HIGH SPEED RAIL (LONDON - WEST MIDLANDS)

Supplementary Environmental Statement 3 and
Additional Provision 4 Environmental Statement

CFA11 Stoke Mandeville and Aylesbury

SES3 and AP4 ES 3.2.1.11

Figure 1: Locations of design changes not requiring a change to the Bill in CFA11

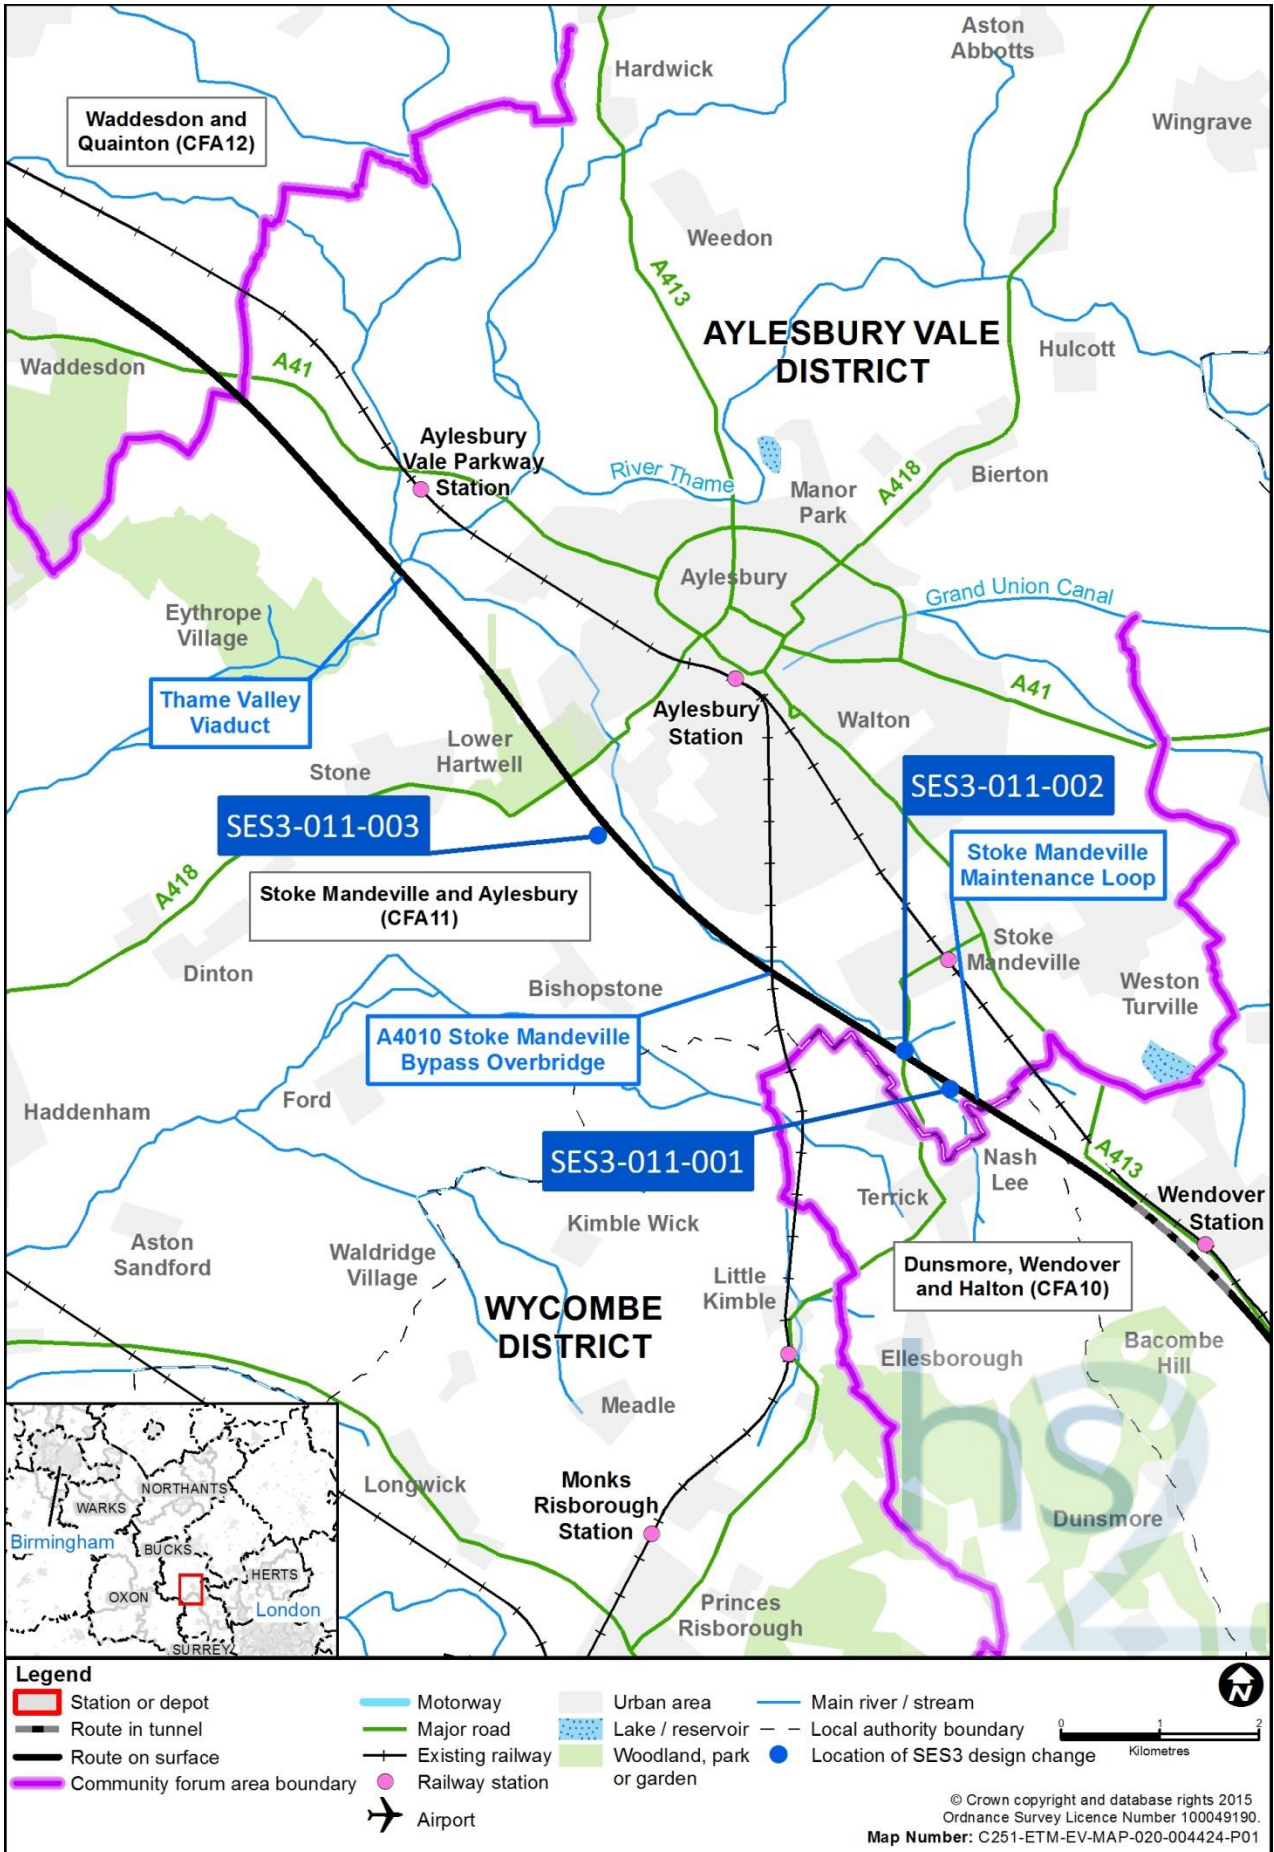
2.2.1 Table 2 provides a summary of the changes to the design or construction assumptions not requiring a change to the Bill which will result in new or different significant effects in the Stoke Mandeville and Aylesbury community forum area (CFA11). Figure 1 shows the locations of the changes.

Name of design change or construction assumption	Description of the SES scheme	Description of the SES3 scheme
Provision of landscape mitigation planting at Stoke Mandeville (SES3-011-001)	The SES scheme includes provision of a permanent maintenance loop approximately 1.2km long at Stoke Mandeville. An access track will be provided along both sides of the maintenance loop with access/egress from Nash Lee Lane on the east side and B4009 Nash Lee Road on the west side of the HS2 route. Wet grassland/fen habitat will be created along the west side of the HS2 route.	The creation of an area of woodland within the proposed wet grassland, along approximately 530m of the HS2 route, in order to partially screen the sidings from views from the Chilterns escarpment.
Provision of landscape mitigation planting near the A4010 Risborough Road (SES3-011-002)	The SES scheme includes provision of hedgerow planting along the embankments of the HS2 route on both sides, from south of Stoke House to south of Old Risborough Road.	The replacement of the proposed hedgerow with a belt of trees in order to help screen views from Stoke House and properties along Old Risborough Road.

Provision of a noise barrier at Sedrup ditch (SES3-011-003)	The SES scheme does not include the provision of noise mitigation on the west side of the HS2 route in the vicinity of Sedrup Lane, Stone.	The erection of a 3m high noise fence barrier along the west side of the HS2 route, to the east of Sedrup Lane, for a length of approximately 350m to reduce operational noise effects in Sedrup.

Figure 2: Locations of amendments in CFA11

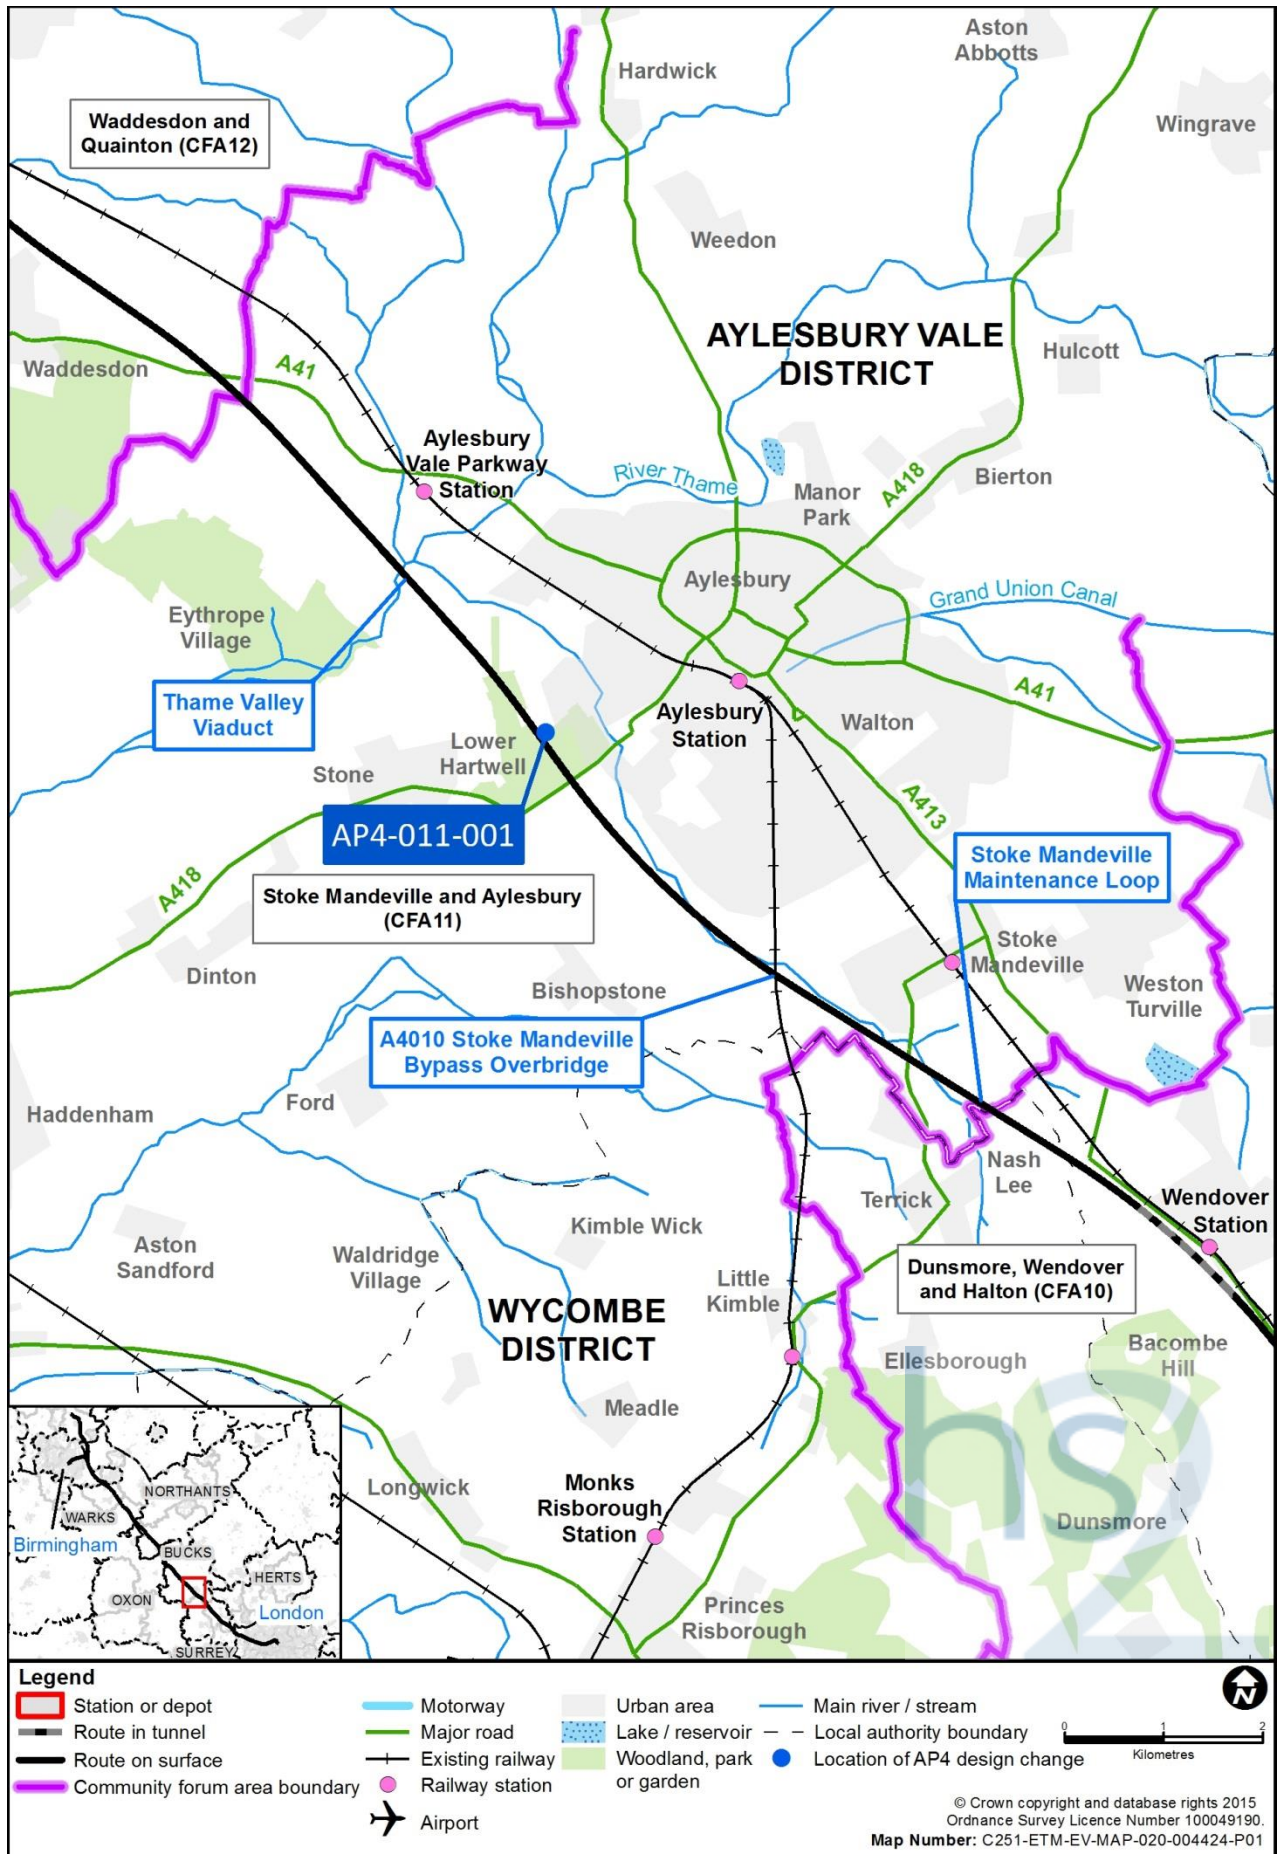
- 4.1.1 Table 4 provides a summary of the amendment in the Stoke Mandeville and Aylesbury community forum area (CFA11) and Figure 2 shows the location.

Name of amendment	Description of the SES ₃ scheme	Description of the AP ₄ revised scheme
Relocation of Footpath overbridge SBH/32 in Lower Hartwell (AP ₄ -011-001)	The Bill provides for a permanent overbridge west of Aylesbury Park Golf Club, approximately 12m above existing ground level, providing a reinstatement of Footpath SBH/32 on its current alignment.	The overbridge will be moved permanently by approximately 70m northwards in order to avoid the removal of existing vegetation and trees at Rifle Spinney. The vegetation and trees will also screen the newly positioned overbridge. An additional balancing pond is proposed. One replacement floodplain storage will be increased in size by approximately 0.1ha and a new replacement floodplain storage of approximately 0.2ha is proposed on the east of the HS2 route.
